DEFENCE SIGNALS DIRECTORATE

MINUTE PAPER

18/11/2

MARSIK 400 HZ POWER SUPPLY

SKETCH 1

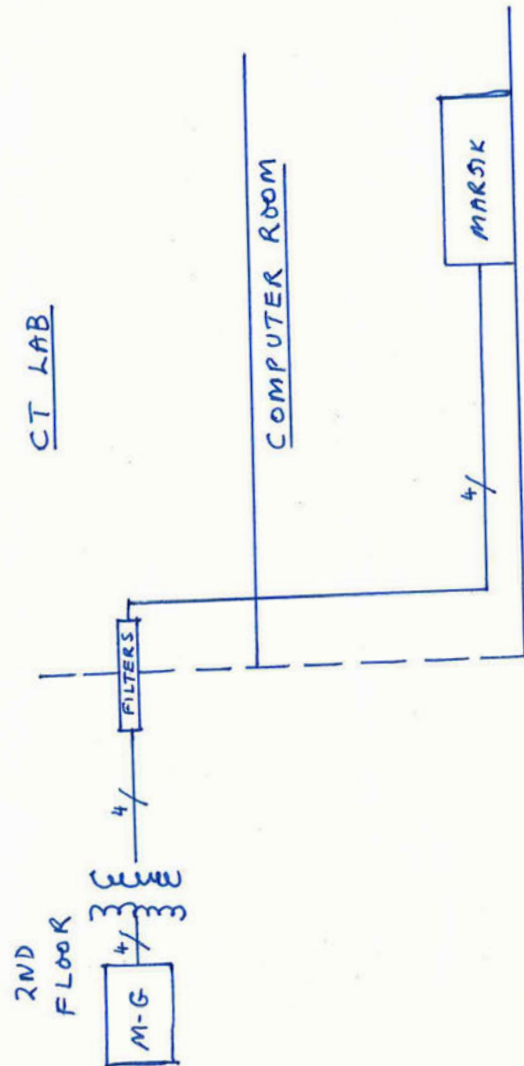
1. Locations proposed to date for major 400 Hz equipment items are 4th floor plant room (M-G sets) and 2nd floor plant room (isolating transformer) ... - refer to Annex A, Sketch 1. Cable runs are long, and losses high.
